IEEE P802.11

Wireless Access Method and Physical Layer Specification

**Text Updates to Section 6 from Sub-Group
Work**

Compiled by Michael Fischer

Figure 6-4: IFS Relations

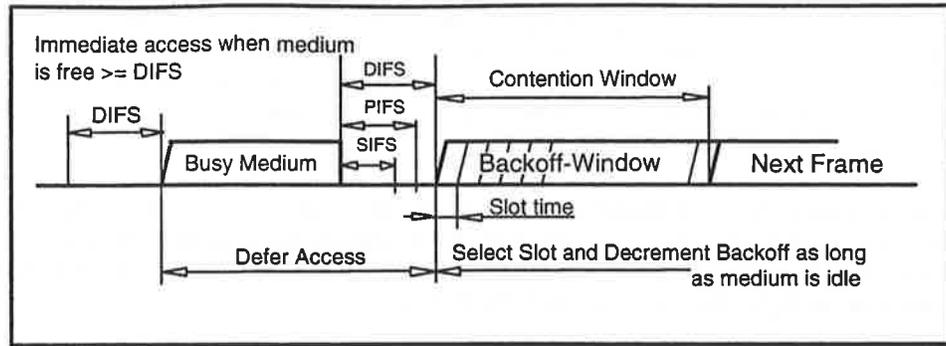
The IFS timings are defined as time gaps on the medium. ~~The standard shall specify the relation of the relative PHY MIB parameters to achieve the specified timegaps as further specified in section 6.2.13.~~
